81-W-501	81-P-501 A/B/C/D/E/F/G
COOLING TOWER PACKAGE	COOLING Water PUMPS
Normal Water Flow Rate 5000 m ³ /h (Each Cell)	CAPACITY (Normal) 55000/560 m ³ /h
	Max. DIFFERENTIAL PRESSURE 5.44 barg
	NUMBER OF PUMPS 5+2
81-W-503	81-W-504
CORROSION INHIBITOR DOSING PACKAGE	DISPERSANT DOSING PACKAGE

00	ISSUED FOR COMMENT	18-Dec-2024	M. HASSANI	M. JAMSHIDI	M. JAMSHIDI	SHAFAHATI
REV.	PURPOSE OF ISSUE	ISSUE DATE	PREPARE	CHECKED	APPROVED	
OWNERS		INC:		CONTRACTOR/CONSULTANT:		
PROJECT TITLE:			PROPANE DEHYDROGENATION (PDH) PROJECT			
DOCUMENT TITLE:						
PFD for Cooling Tower System						
DOC NO.:	PROJ.CODE	Sec.	PHASE	DEP.	DOC. TYPE	SERIAL NO.
	3981	50	DE	PR	PFD	020
SCALE: 1:100	SIZE: A3	SHEET NO.: 1 OF 1		REVISION: 01		CLASS: 1

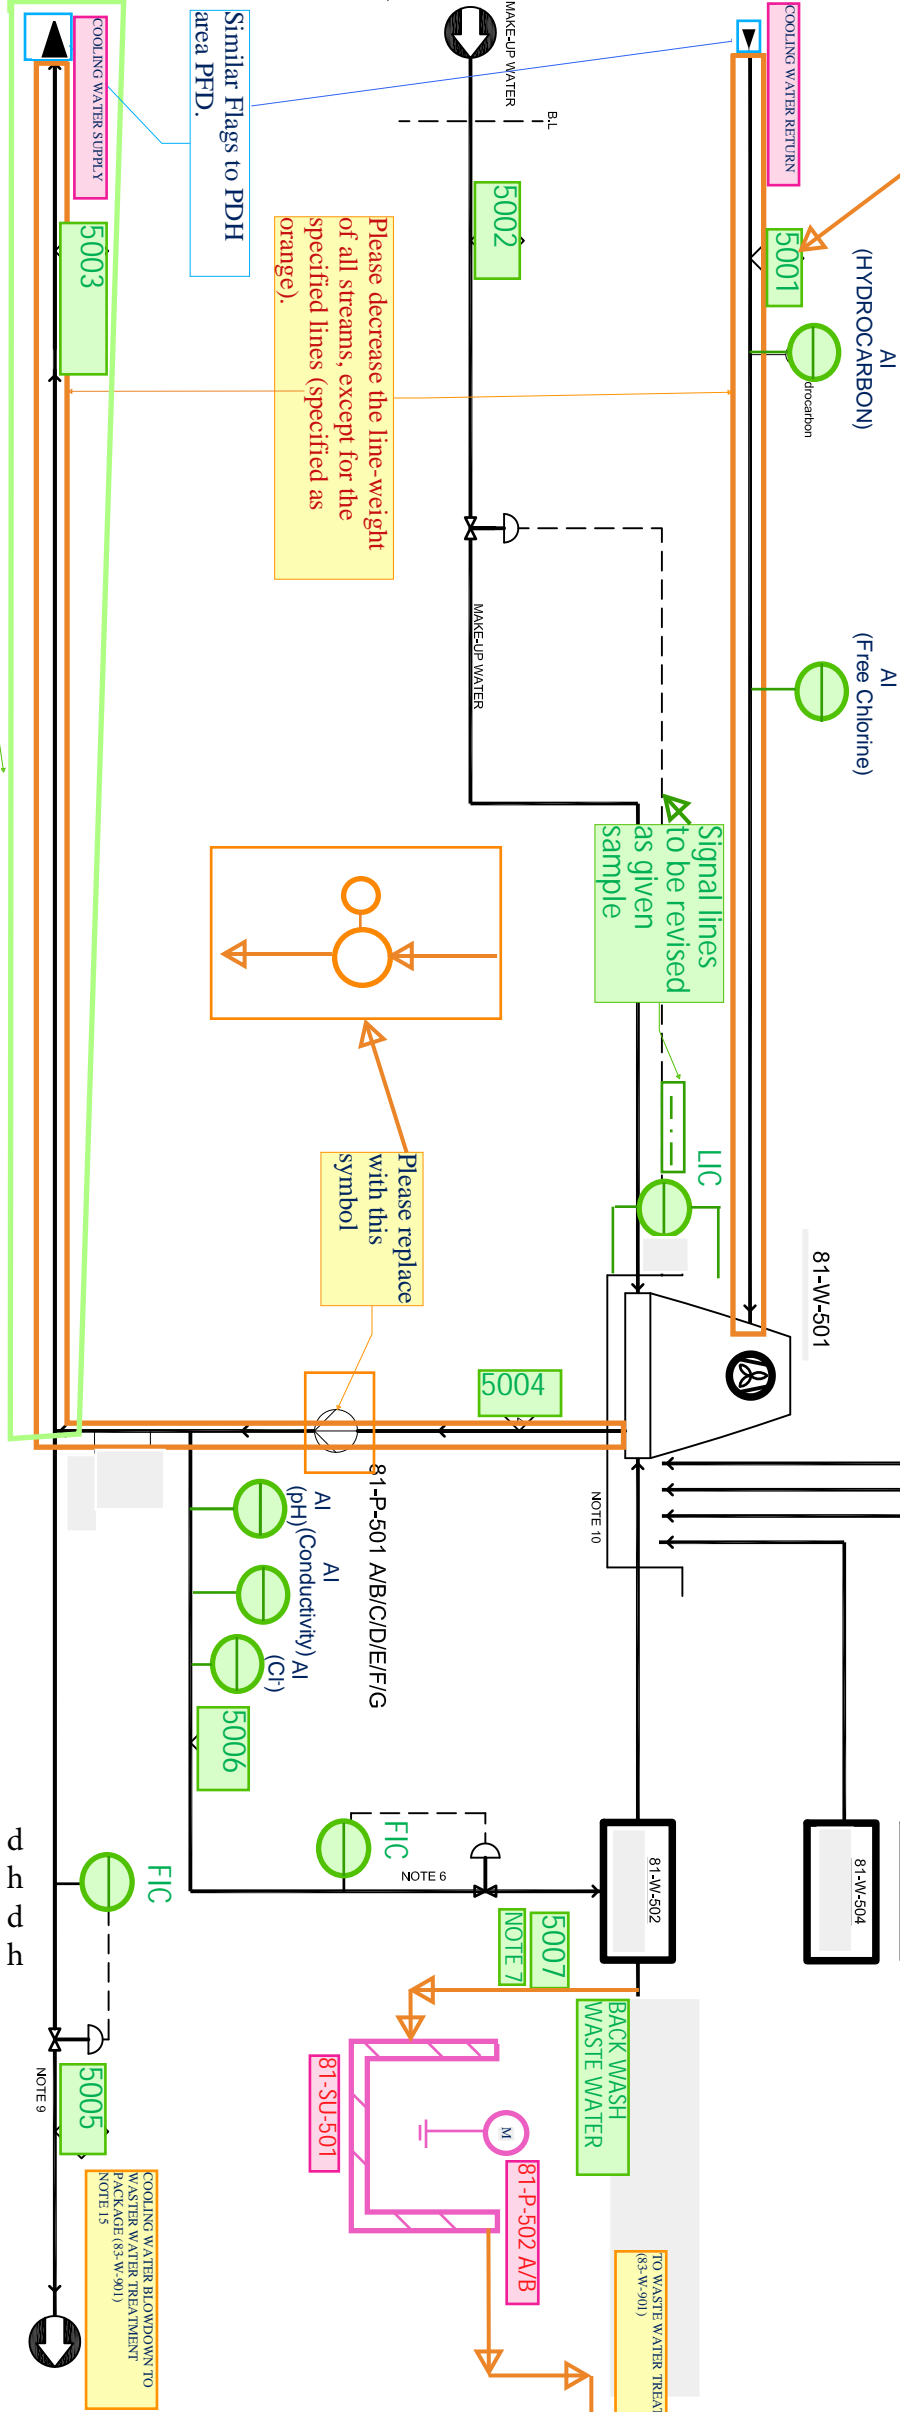
Please delete all old stream
numbers and replace them
with new ones, shown as
below

Please move this branch
lower.

Please decrease the line-weight
of all streams, except for the
specified lines (specified as
orange).

Please replace
with this
symbol

To be deleted.

Stream NO.	5001	5002	5003	5004	5005	5006	5007 (Note 7)
TEMPERATURE, °C	47	25	37	37	37	37	37
PRESSURE, Barg	3.5	5.5	5.5	0.31	5.5	5.5	2
TOTAL MASS FLOW, kg/h	24960575	532430	24960575	26283485	74882	1248029	520
DENSITY, kg/m ³	990.7	1007.5	998.4	998.3	998.4	998.4	998.3
VISCOSITY, cP	0.57	0.89	0.69	0.69	0.69	0.69	0.69
